ADDENDUM #3

CITY HALL HVAC UPGRADE

BID #14/15-008 – PWP# WA-2015-012

**SPARKS CITY HALL
 CAMPUS HVAC UPGRADE
 SPARKS, NEVADA**

SHEET NUMBER :
E1.2

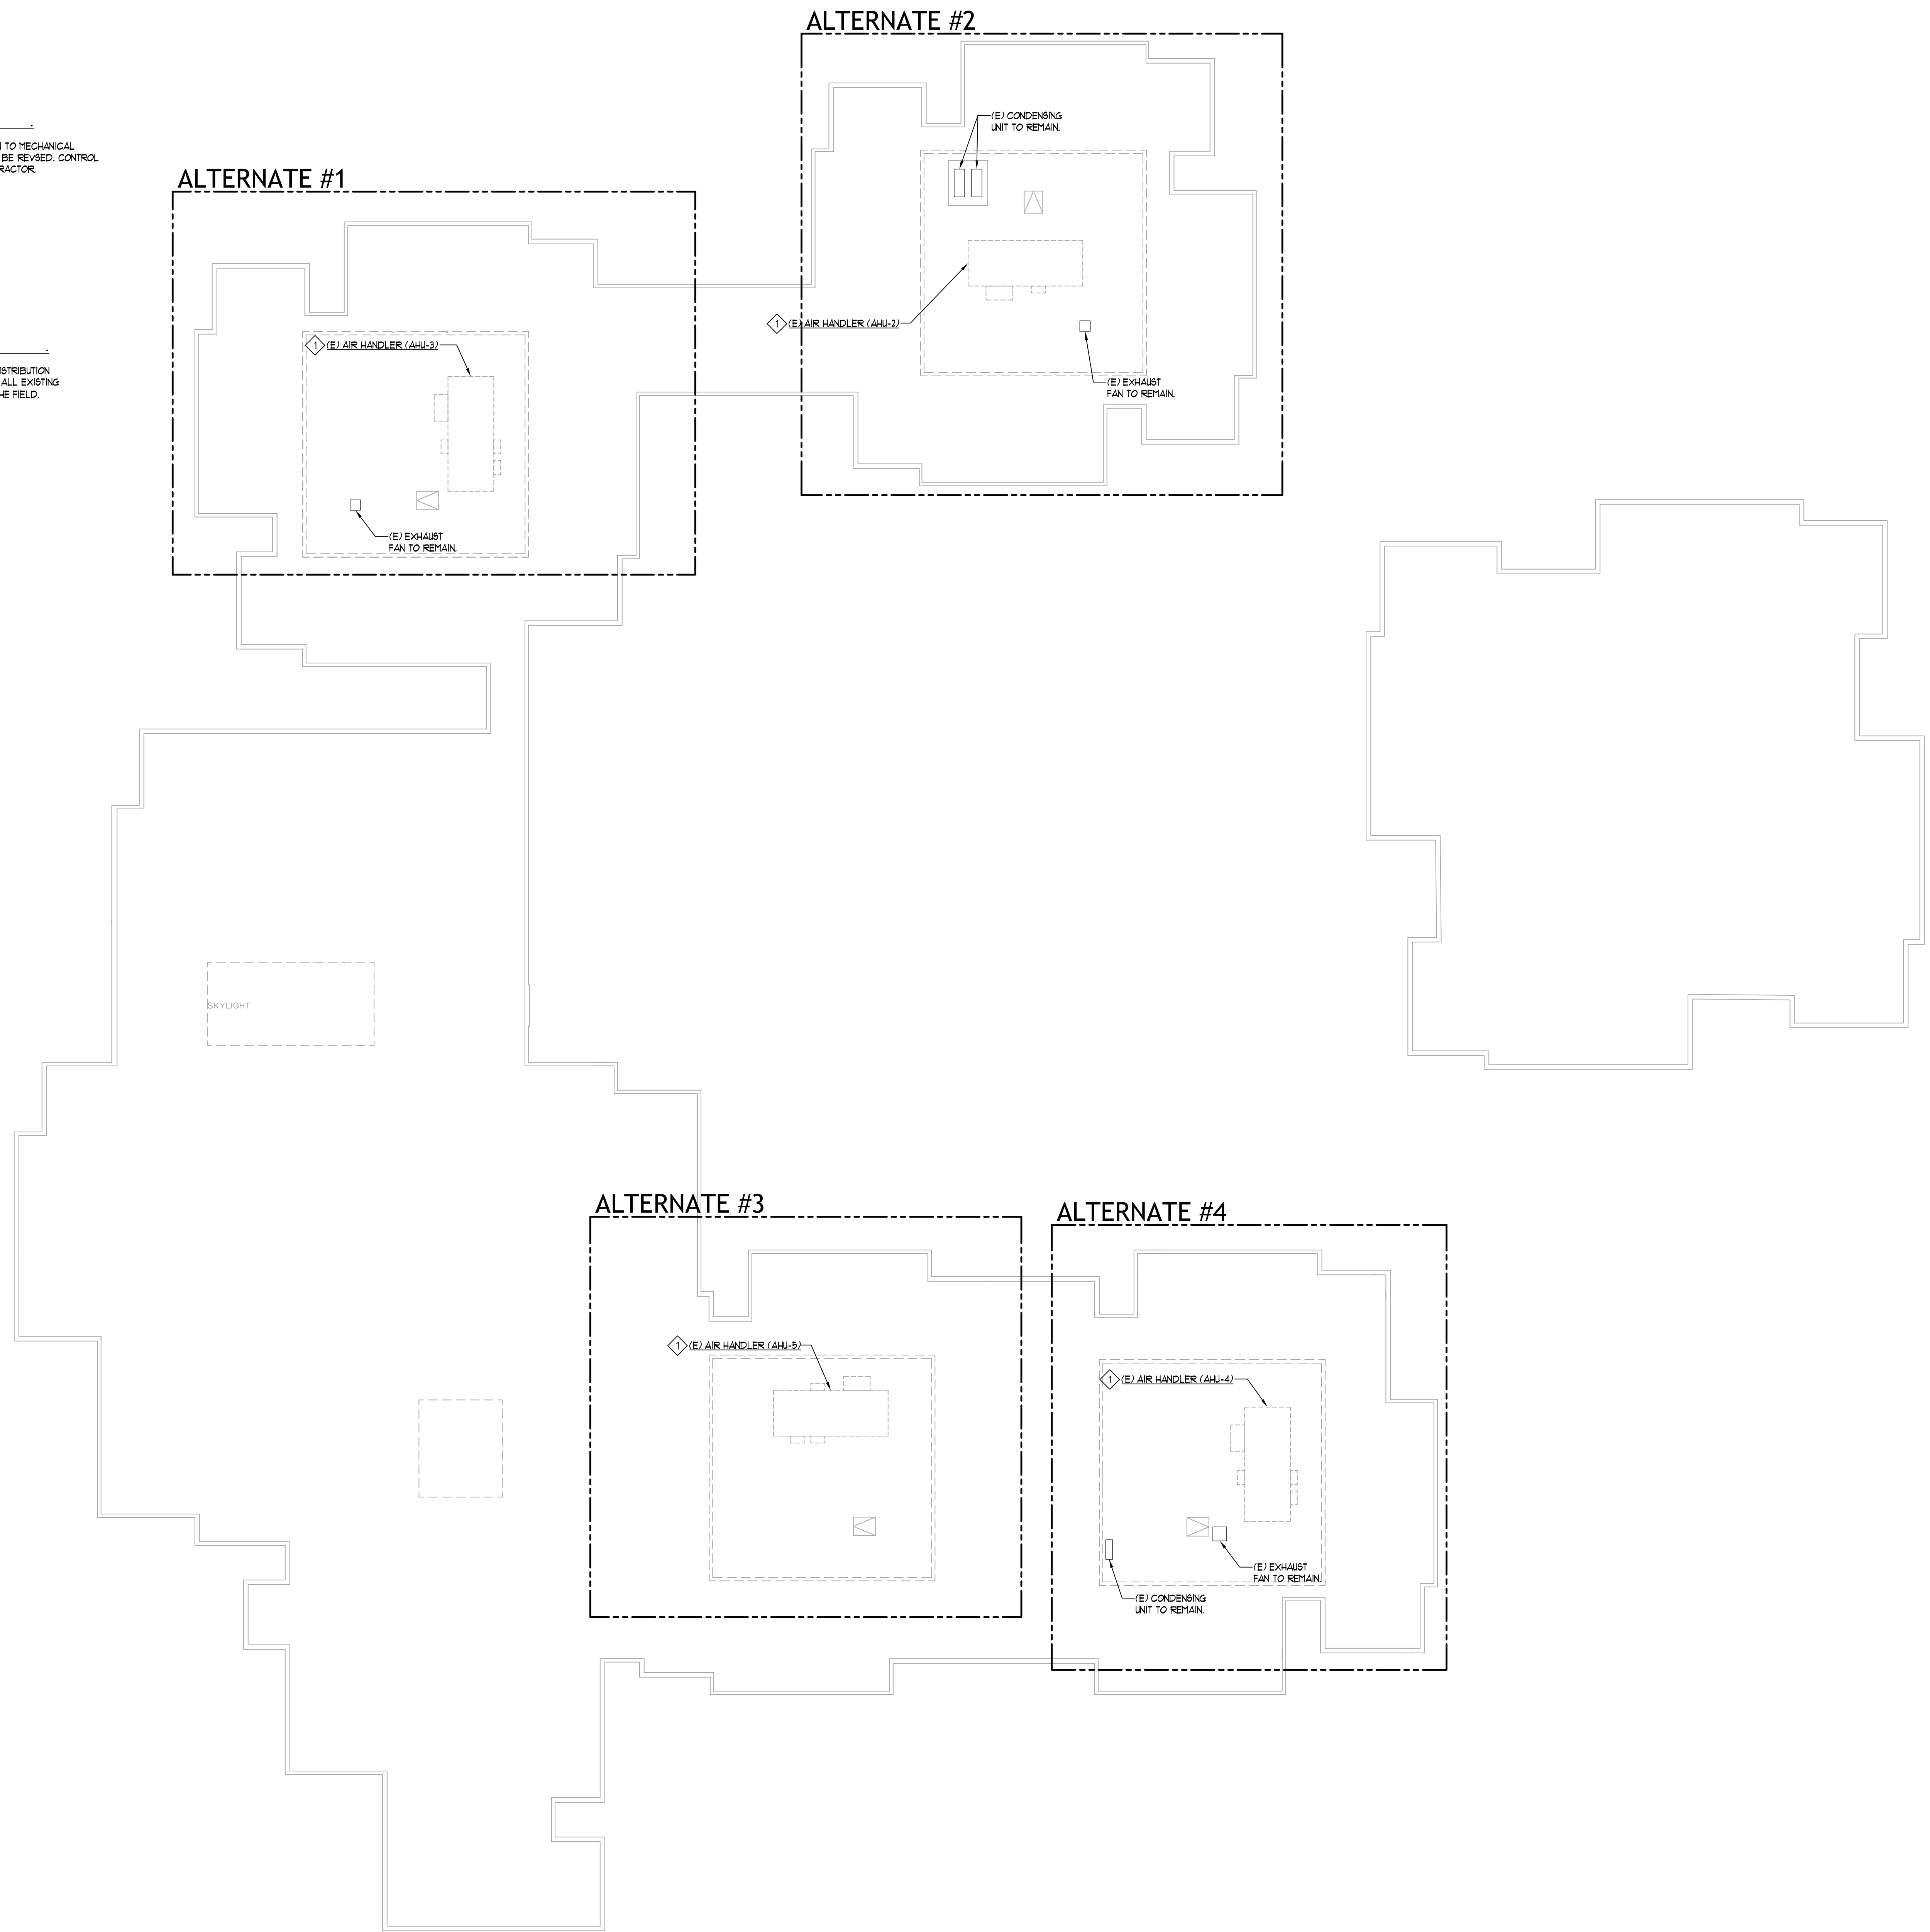
IF ALTERNATE 1-4 ARE NOT ACCEPTED THEN THE EXISTING AIR COMPRESSOR WILL BE RELOCATED AND RECONNECTED. COORDINATE NEW LOCATION WITH MECHANICAL CONTRACTOR.

**BUILDING #400 (NORTH HALF) BASEMENT
ENLARGED NEW MECHANICAL POWER PLAN**
SCALE: 3/8"=1'-0"

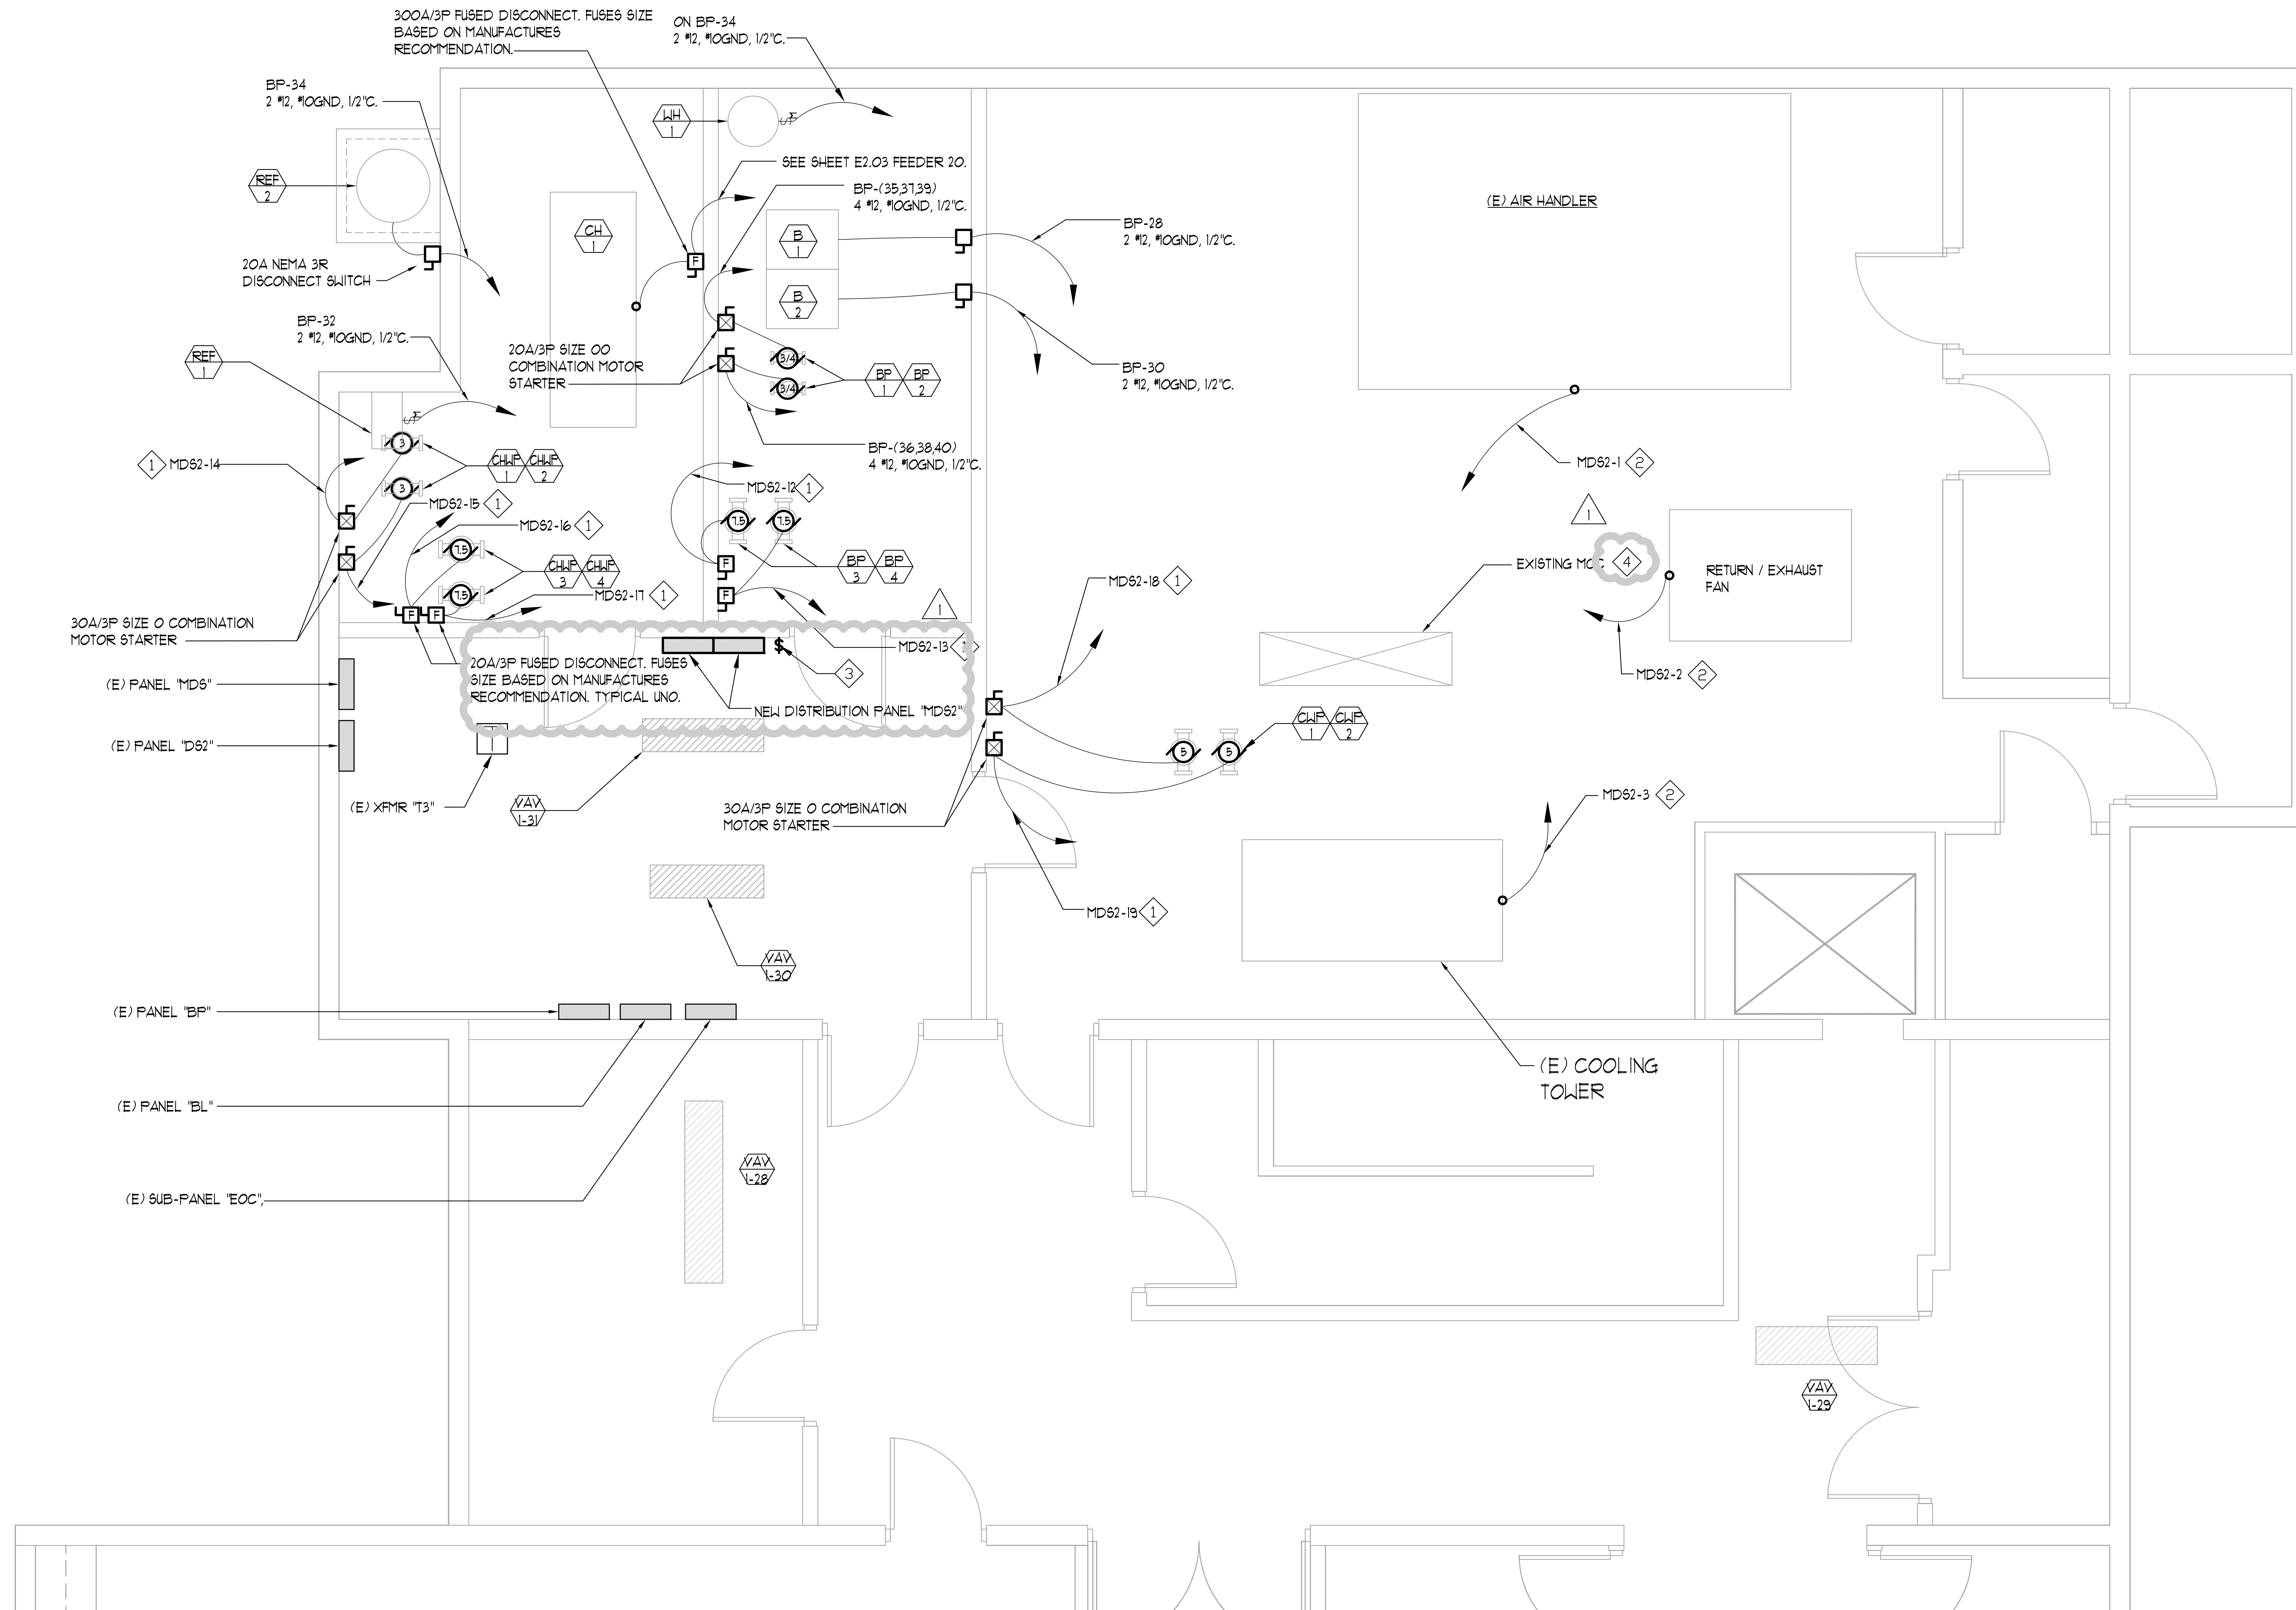
- 1 ELECTRICAL CONTRACTOR TO CONNECT MECHANICAL EQUIPMENT. CONTROL WIRING TO BE COMPLETED BY MECHANICAL'S CONTROLS CONTRACTOR. SEE FEEDER SCHEDULE ON SHEET E0.3 FOR CONDUCTOR SIZES.
- 2 CONNECT EXISTING EQUIPMENT'S NEW VARIABLE FREQUENCY DRIVES (VFD). SEE FEEDER SCHEDULE ON SHEET E0.3 FOR CONDUCTOR SIZES.
- 3 NEW LOCATION FOR BOILER SHUTDOWN SWITCH. CONNECT TO BOTH NEW BOILERS.
- 4 IF ALL ALTERNATES ARE ACCEPTED THEN MCC WILL REMAIN OPERATIONAL DURING CONSTRUCTION AND WILL BE REMOVED AFTER ALL EQUIPMENT CONNECTIONS ARE DISCONNECTED FROM MCC. REMOVE MCC FEEDER AND EXPOSED CONDUIT WHEN MCC IS REMOVED.
